EGL Ref: 9702

**MATAKANUI GOLD LIMITED
BENDIGO-OPHIR GOLD PROJECT- FAST TRACK APPROVALS ACT
RESPONSE TO OTAGO REGIONAL COUNCIL
SHEPHERDS VALLEY CREEK REALIGNMENT**

Engineering Geology Limited (EGL) is engaged by MGL to provide geotechnical, earthquake and dam engineering services for the BOGP. This letter sets out EGL's response to select ORC's queries dated 12 December 2025¹: Questions 4 and 6.

This letter version dated 17 February 2026 has been issued as draft to support GeoSolve's response to ORC.

Figure 1: Site access road fill through the gorge at the exit of Shepherds Valley, looking east.

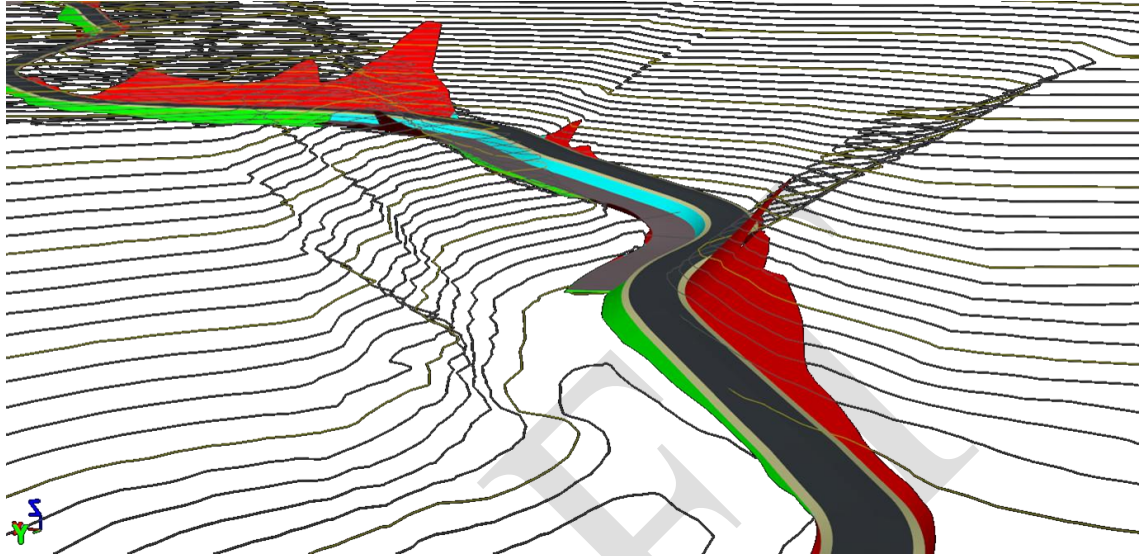
Please provide the following information in relation to the proposed diversion of both Shepherds Creek and 'SREX tributaries':

- a) *Channel diversion / realignment path design details*
- b) *Engineering drawings*
- c) *Channel lengths, gradients and alignments*
- d) *Proposed construction methodology*
- e) *Erosion control or armouring details specific to the channel*
- f) *Hydraulics / flood design calculations to support channel sizing*

The valley exit will be filled through the 'gorge' to form the site access road. A 3D concept of the area is shown in Figure 1. The gorge is formed in TZ4 schist rock with steep side slopes as shown in the Figure 2. The opening is narrow and therefore the

site access will be formed primarily on fill with Shepherds Creek realigned on fill on the north side of the gorge. Some cut may also be required. The channel for the Shepherds Creek realignment in this zone will be lined with armour rock (riprap).

The site access road will be stabilised with a wearing course and therefore sediment control measures will not be required in this area during operation.

Figure 10

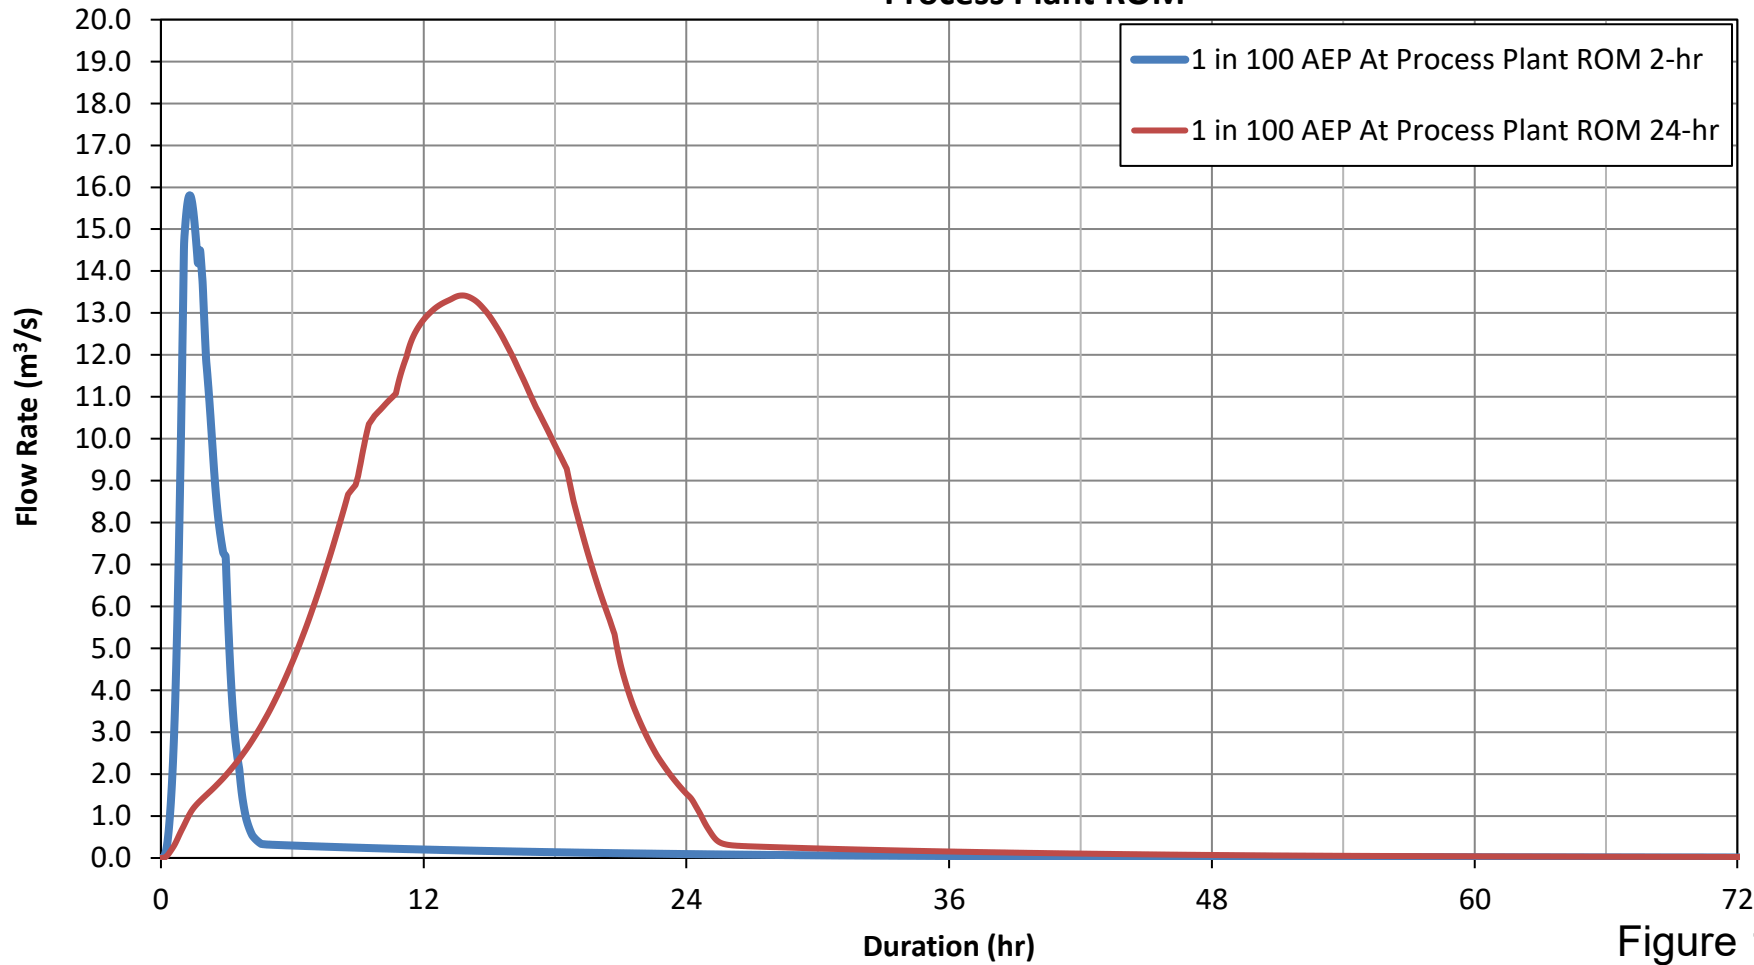
Please provide an assessment from a suitably qualified and experienced person of the flood carrying capacity of the proposed Shepherds Creek diversion channel. Specifically, this assessment should include:

- a) *Whether this channel will be capable of conveying 100-year ARI (1% AEP) flood flows.*
- b) *If the channel cannot accommodate the flows described in part (a) without overtopping,*
- c) *an assessment of the potential consequences of overtopping.*
- d) *Clarification of whether the proposed channels will be left as-constructed following closure of the mine, and if this is case then an explanation as to how their ongoing performance will be assured.*

Rainfall runoff has been assessed with a unit hydrograph approach, and flood routing undertaken using the HEC-HMS modelling programme (Version 4.12). The peak flow estimates are summarised in Table 2, showing a design peak flow rate of 17.6 m³/s past the ROM pad at the Process Plant, and 20.4 m³/s at the valley exit for a 6-hour duration storm. Hydraulic routing curves are attached.
